TSG-RAN Working Group 3 meeting #6 Sophia Antipolis, France, August 23-27, 1999

Source: Alcatel

Title: Synchronised RL Reconfiguration procedure for DSCH

Figure 9-4. RL Reconfiguration procedure (synchronised)

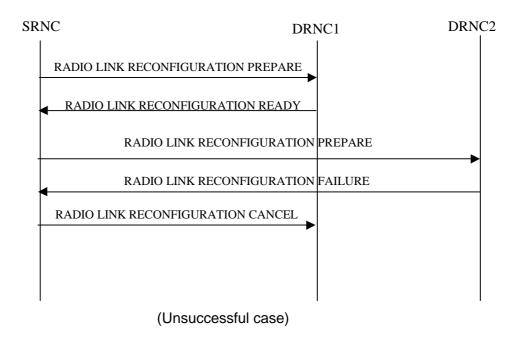
It is proposed to modify section 8.2.4 of TS 25.423 [2] as follows:

- TFS of the added/modified DCH
- <u>DSCH Related Information (DSCH Identifier, RL Identifier, MAC-d/MAC-sh DL Transport Format Set)</u>

Radio Link Reconfiguration (Synchronized) Procedure

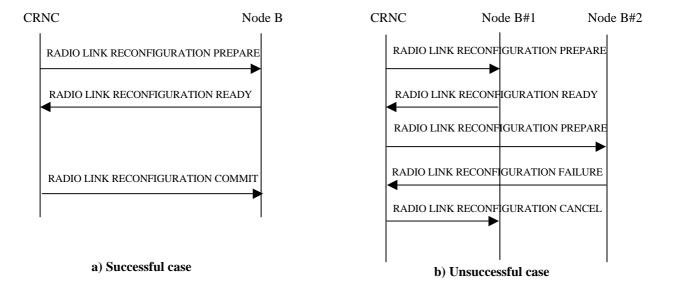
It is proposed to modify section 8.2.2 of TS 25.433 [3] as follows:

- UL Radio Resources (UL Channelisation code type)
- DL Radio Resources (DL Channelisation code per RL<u>in the DCH case</u>) (if changed)
- Transport Format Combination Set

<u>Transport layer addressing information (Transport layer address, binding ID) for modified DSCH</u>
